Request for Class II Permissive Change

FCC ID: VG8EM145AXX-P Data: 2012-5-13

Please be notified that we, the undersigned, Guangdong Midea Microwave and Electrical Appliances Manufacturing Co.,Ltd. declare that the reasons for this class II permissive change are as below:

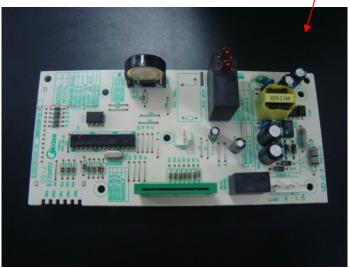
1. Updated Mainboard as below:

Changed linear power supply to switching power supply

or below switching power supply.

Between of linear power supply and switching power supply have the same specification of rated output power, changed to the switching power supply, theirs rated output power have not obvious change.

The differences of between this two switching power supply only is PCB layout and components location, anything else are the same.
